CITY OF SUGAR HILL

IFB # 17-003 – ROADWAY IMPROVEMENTS ON VARIOUS CITY ROADS

ADDENDUM #1

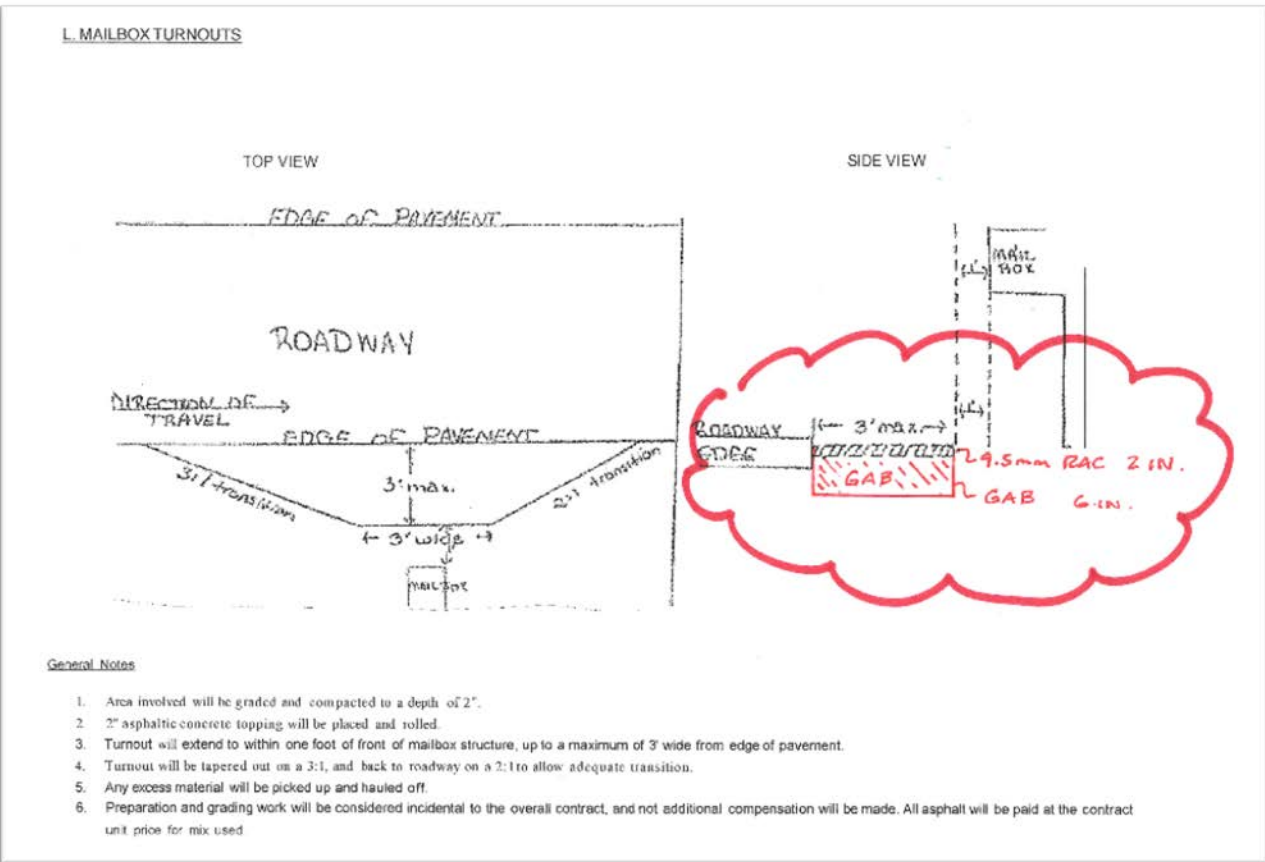
Q16: Will the contractor be required to place GAB on existing unpaved driveways and at mailbox turnouts of this project?

A: The mailbox turnout detail shall be amended to require six (6) inches of GAB under the asphalt concrete as shown in the amended detail below. Unpaved driveways shall be topped with GAB to the depth of the drop-off created from the edge of pavement to the right-of-way.
